SOUTH MARSTON
PARISH COUNCIL

SMPC response to S/COND/23/0848 Revised HHT Phasing Plan

3.8.2023

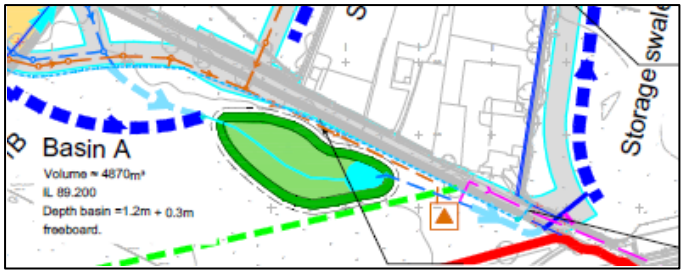
Para 2.5 of the Phasing Plan requires details of the disposal of sewage for that parcel as part of the overall foul drainage strategy. We note the proximity in the Phasing Plan map of the pumping station to the main SUDs drainage 'Basin A' which receives the overwhelming majority of surface water flow from South Marston.

This is a different arrangement than that shown in the Foul Water Management Plan approved in 2022 and reproduced in the draft Brookbanks Surface Water Drainage layout plan Jan 2022 reproduced here. We hope the Phasing Plan will be corrected in line with the Foul Water Management Plan

Notwithstanding the above, we are concerned that the foul water pumping station for South Marston expansion is located very close to the planned Basin A, given the latter's importance. The same area is also close to that earmarked for use in the construction phase for the OVL/ Primary Street junction (CEMPMS plan submitted July 2022), in particular arrangement for disposal of silt etc. Para 3.1 of the CEMP states '*There will be no discharge of foul or contaminated drainage from the site into either groundwater or any surface waters, whether direct or via soakaways'.*
